## Access Compliance Report Public Rights-of-Way (Curb Ramps)

Intersection ID: 13749Main Street:BARRINGER\_DRCross Street:REMOUNT\_RDLocation:NEADA ID: 7D354BFFCA6BRamp Type:PerpInitial Pass/Fail:FailOverall Compliance:NoSeverity Score:8.75

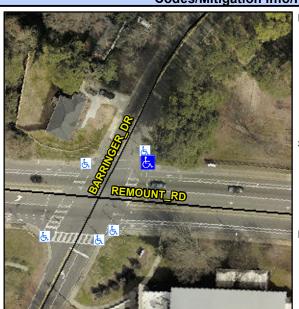
Possible Solutions:					
Remove & Replace Entire Ramp.					
Surveyor Notes:					
N/A					
DDOW/ADA					
PROW/ADA:					
R304.5.1					
I

Field Measurements/Component Compliance						
Compliance Description		Data	Comp	oliance Description	Data	
N/A	Ramp Length (in)	60.0	Yes	Ramp Slope (%)	5.4	
No	Ramp Width (in)	38.0	Yes	Ramp XSlope (%)	1.8	
N/A	Flare Type LT	N/A	N/A	Flare Type RT	N/A	
N/A	Flare Slope LT (%)	N/A	N/A	Flare Slope RT (%)	N/A	
N/A	Flare Traversable LT?	N/A	N/A	Flare Traversable RT?	N/A	
N/A	Landing Length (in)	N/A	N/A	DWS Provided?	N/A	
N/A	Landing Width (in)	N/A	N/A	DWS Contrast?	N/A	
N/A	Landing Slope (%)	N/A	N/A	DWS Length (in)	N/A	
N/A	Landing X Slope (%)	N/A	N/A	DWS Full Width?	N/A	
N/A	Landing Curb? (Y/N)	N/A	N/A	DWS Offset (in)	N/A	
N/A	Shared Landing?	N/A				
N/A	Gutter Ponding?	N/A	N/A	Gutter Slope (%)	N/A	
N/A	Gutter Lip Ht (in)	N/A	N/A	Gutter X Slope (%)	N/A	
N/A	Painted X Walk1?	Yes	N/A	Painted X Walk2?	N/A	
	X Walk 1 Direction	To SW		X Walk 2 Direction	N/A	
N/A	X Walk 1 Width (in)	116.0	N/A	X Walk 2 Width (in)	N/A	
	X Walk 1 Slope (%)	0.8		X Walk 2 Slope (%)	N/A
